**Before the  
Federal Communications Commission  
Washington, D.C. 20554**

In the Matter of	)	
	)	
Space Exploration Holdings, LLC	)	File No. SAT-MOD-20200417-00037
	)	Call Signs S2983 and S3018
Application for Modification of Authority for the	)	
SpaceX NGSO Satellite System	)

**PETITION TO DENY OR DEFER OF SES AMERICOM, INC. AND O3B LIMITED**

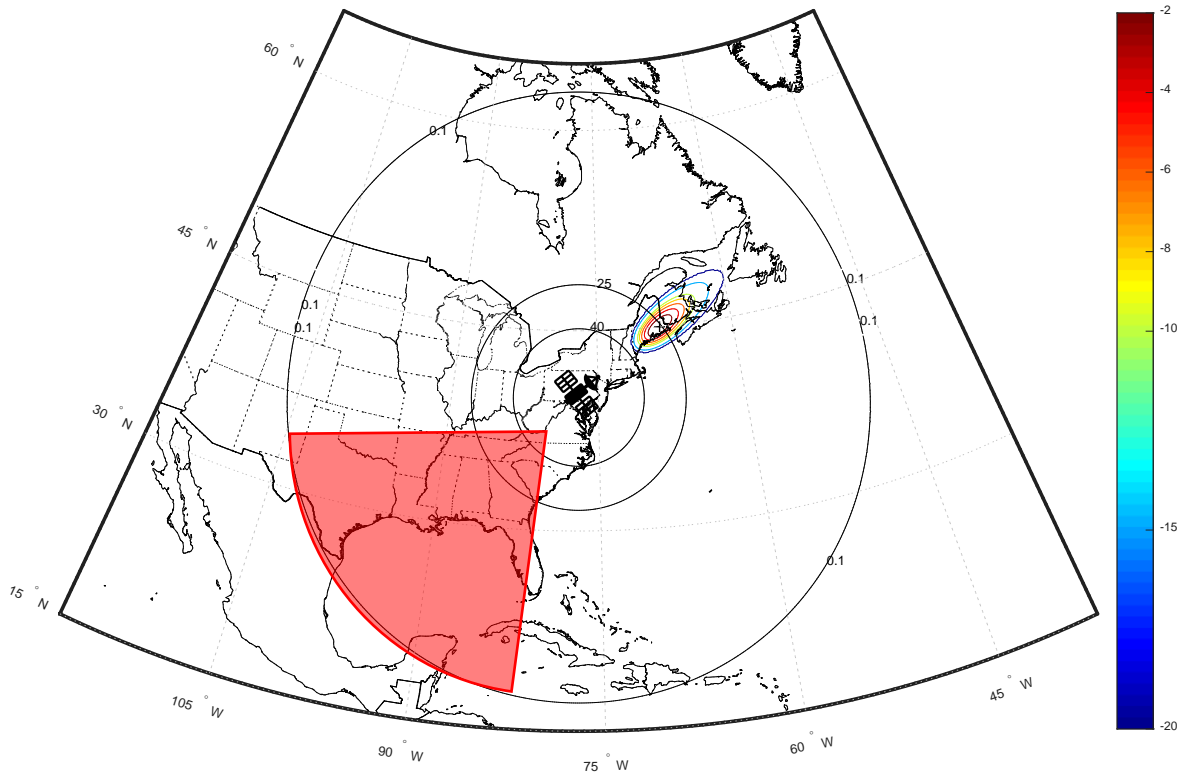
As originally proposed, the SpaceX design contemplated steering and beamforming within the area shown by the 25-degree elevation angle, with scan angles no greater than  $\pm 40$  degrees from nadir, allowing for well-formed beams with no grating lobes. With the modifications requested in the Application, to allow the coverage of each SpaceX satellite to remain the same, the scan angles increase up to  $\pm 57$  degrees from nadir. The larger scan angles substantially increase the possibility of grating lobes arising away from the intended beam target. The most likely area within which these grating lobes would occur is shaded in red in the figure above.

Further information and analysis from SpaceX are required to allow SES and other potentially affected parties to evaluate the magnitude of the resulting interference risk. In particular, SpaceX should provide radiation information for the entire area that could be illuminated by each SpaceX satellite, rather than just depicting the beam characteristics for the intended cell.
